DRAFT FINDINGS OF FACT REQUEST FOR CERTIFICATE OF APPROPRIATENESS VILLAGE REVIEW BOARD

PROJECT NAME: Addition of Second-Floor Balconies

CASE NUMBER: VRB 20-018

LOCATION: 73-75 Union Street (Map U13, Lot 111)

AUGUST 4, 2020 ELEVATIONS

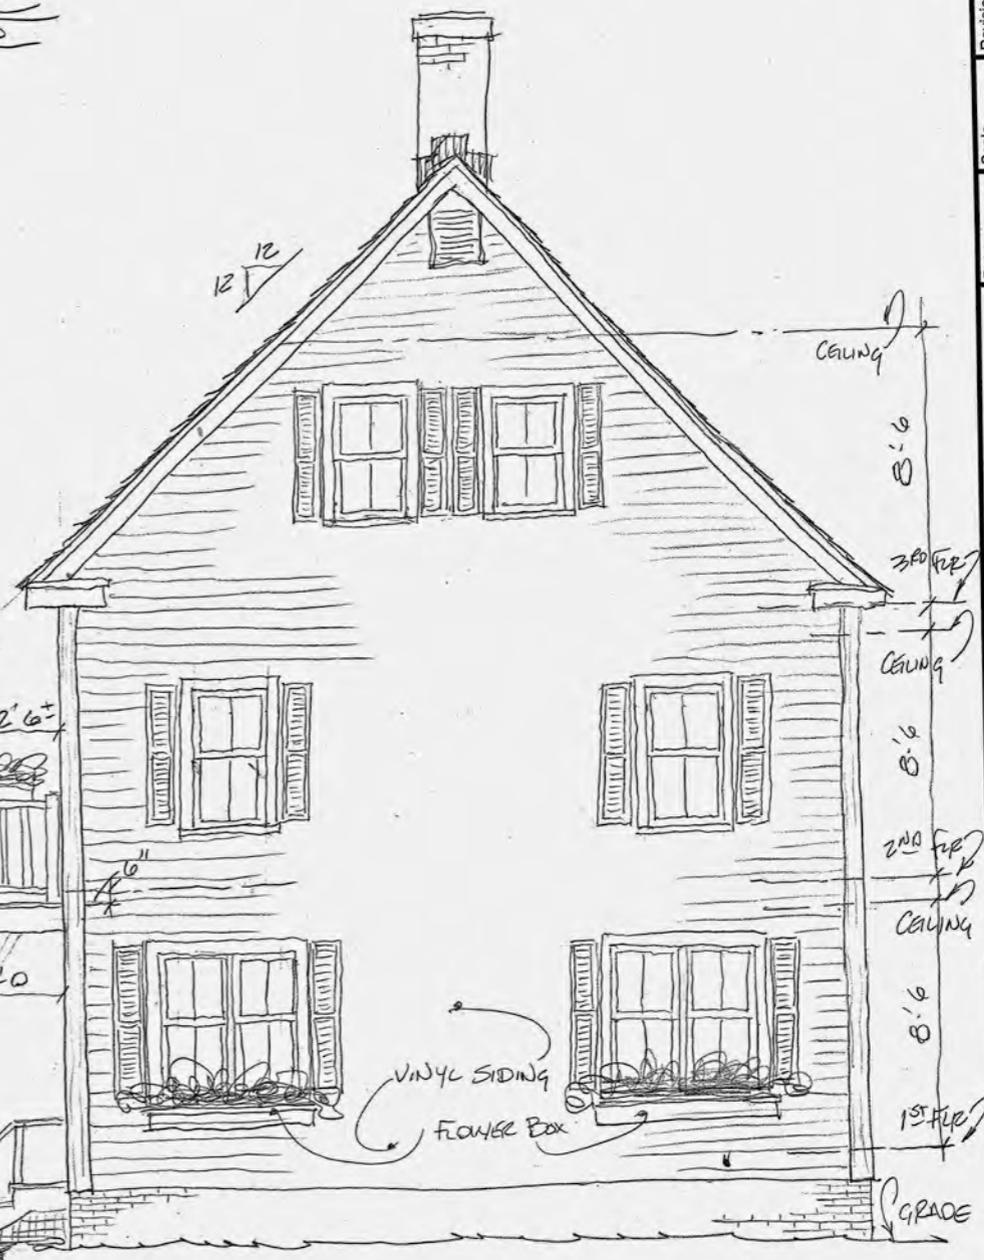
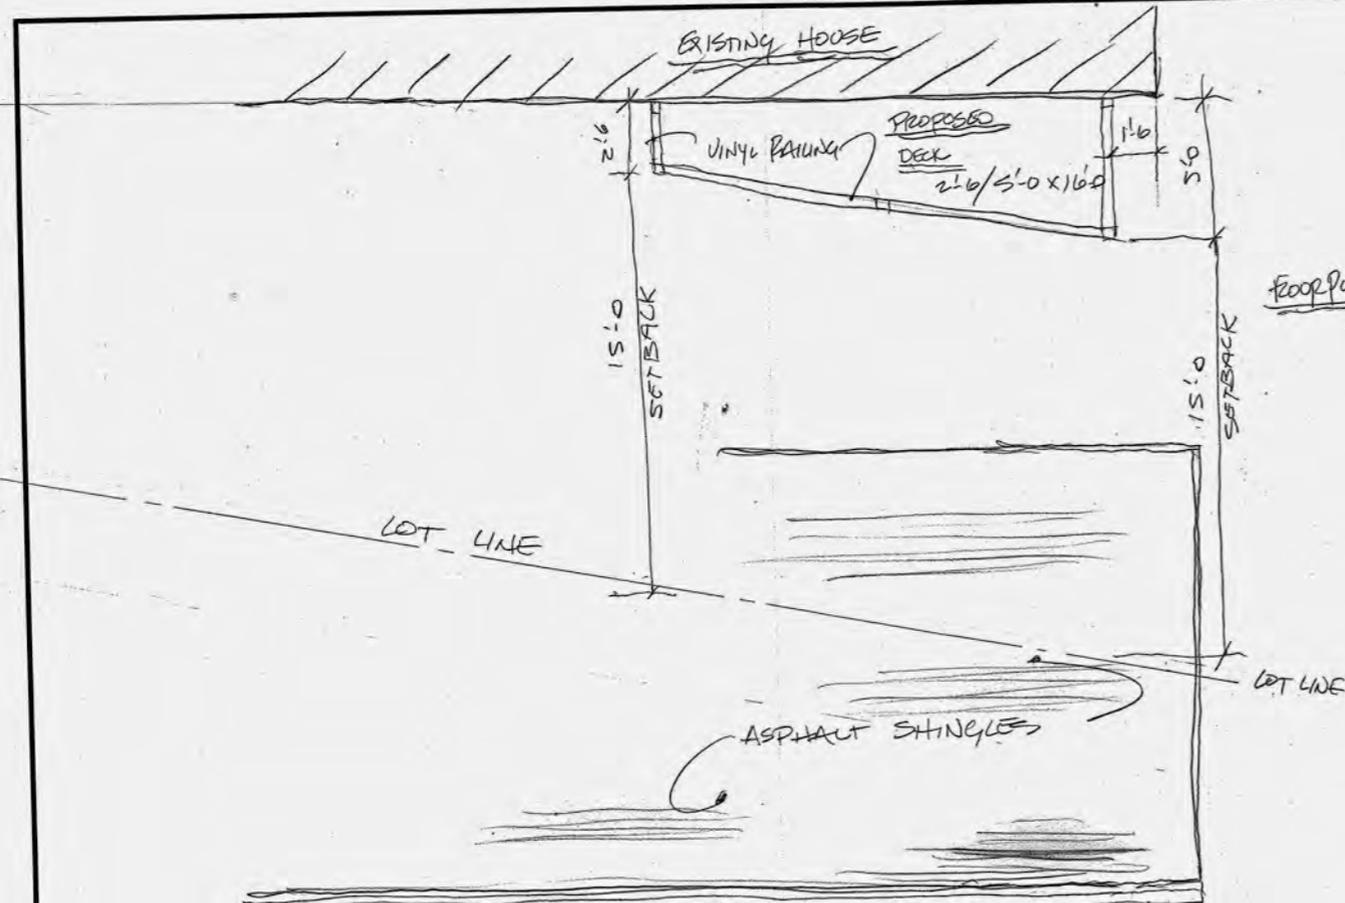
This item first appeared before the Village Review Board (VRB) on August 4, 2020. At that meeting the applicant's request for a Certificate of Appropriateness for Alterations and New Construction to build an approximately 60 square foot, balcony at the northwest corner of the existing structure was tabled. Various members of the VRB expressed their concerns that the proposed balcony was detrimental to the historic integrity of the structure because it altered the existing building symmetry and that it concealed the distinctive architectural character-defining porch roof and brackets.

At the August 4, 2020 VRB meeting staff stated their opinion that the architectural style of the structure reflects a Colonial Revival style and noted that the recently updated VRB Design Guidelines state, “side porches are characteristic of the Colonial Revival style.” Various members of the VRB disagreed and stated that either the structure was not of a Colonial Revival style or that regardless of the style, the preservation of the existing building’s overall symmetry was essential to maintaining its historic integrity.

The proposed balconies require the removal of distinctive features, a window and shutters, of the structure and will alter the prevailing symmetrical arrangement and rhythm of windows on the North side of the second floor. The balconies will also obscure distinctive features, notably the roof over the first story door – four first story doors repeat this feature. The structural columns proposed to support the new balconies obscure the distinctive features – windows and doorway and roof – of the first floor.

- A second balcony on the southwest corner of the structure.
- Integration of the porch roof brackets into the balcony supports (the porch roofs will be removed).
- The reconstruction of the existing entrance steps at the northeast and southeast corners of the structure to match the materials and design of the proposed balconies.
- Planter boxes on the proposed balconies to match the existing planter boxes on the first-floor windows.

AUGUST 18, 2020 ELEVATIONS

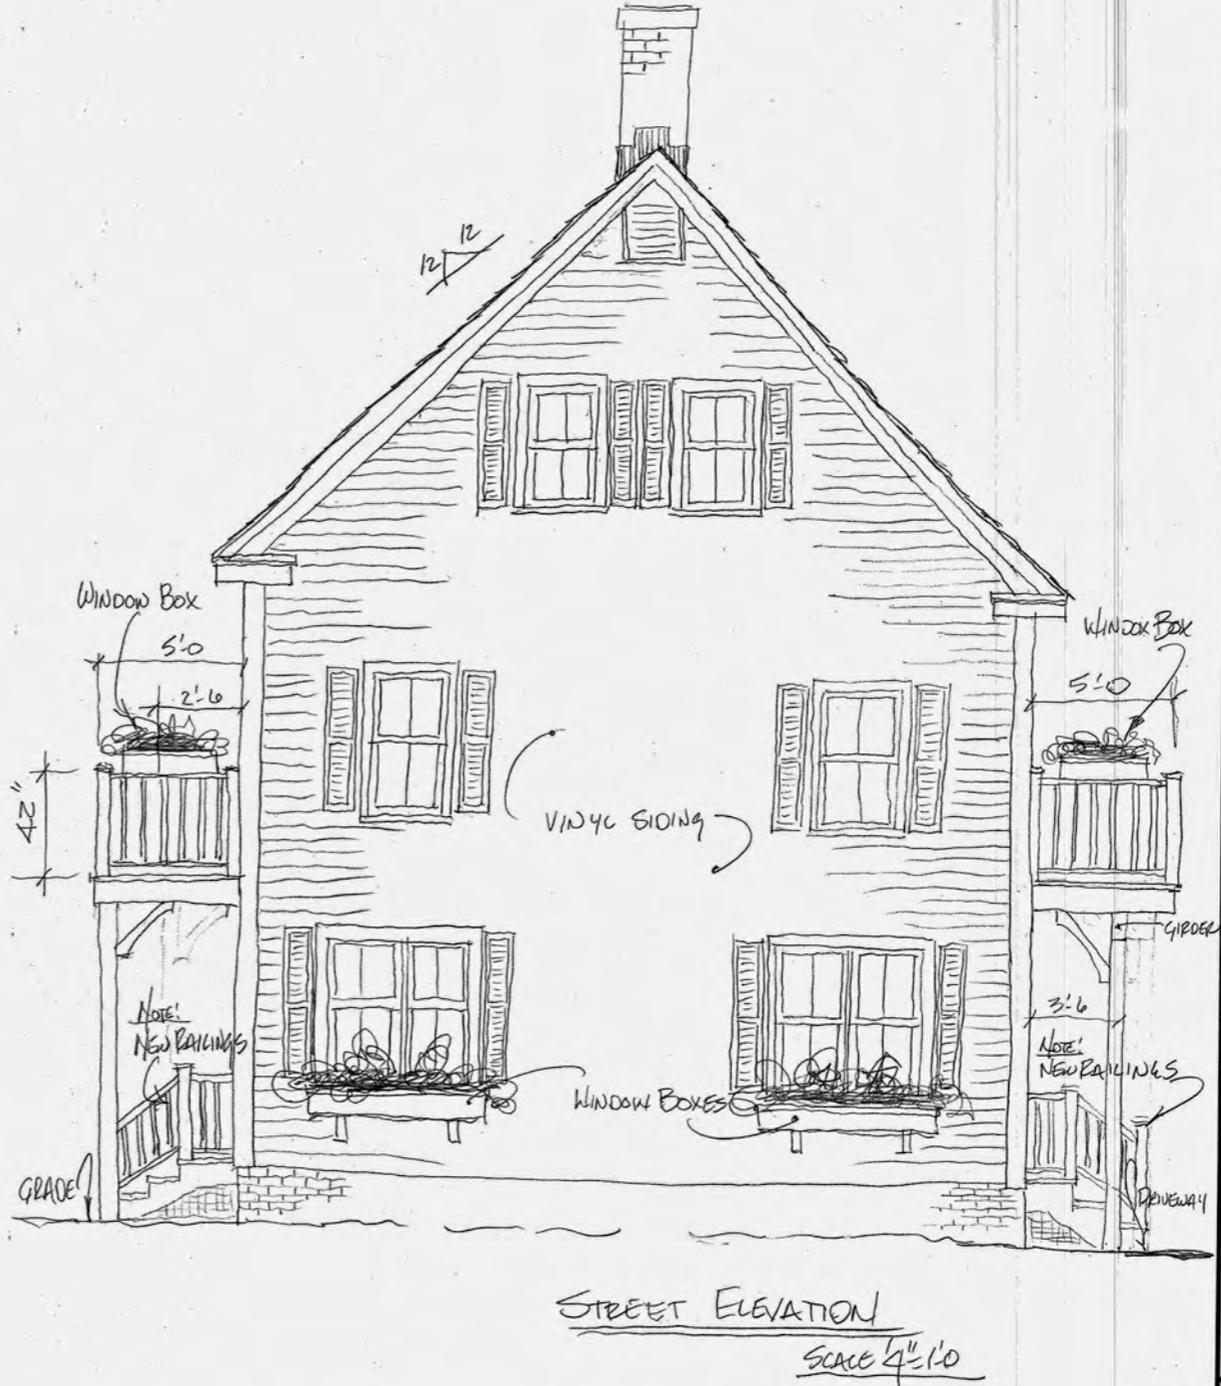
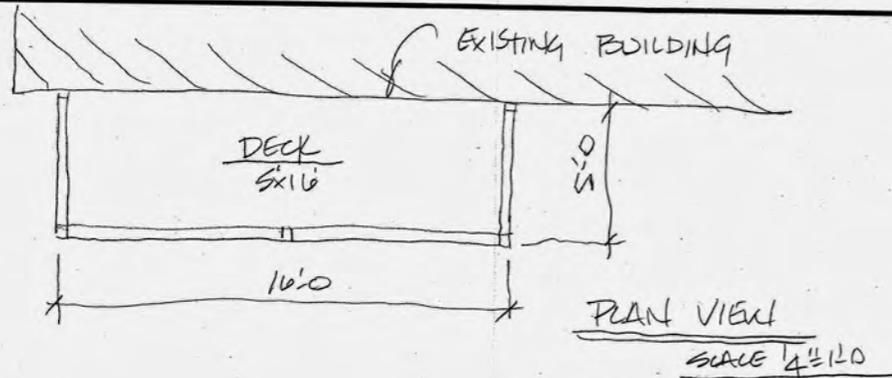
The proposed northwest balcony still tapers toward the east to comply with the side setback established in Table 4.2.3: Dimensional and Density Standards for Growth Area Zoning Districts of the Brunswick Zoning Ordinance.

The applicant's plans indicate the use of a vinyl railing for the proposed balconies. Although not a preferred material, the vinyl railing is consistent with the existing vinyl siding. No asphalt or asbestos materials are proposed.
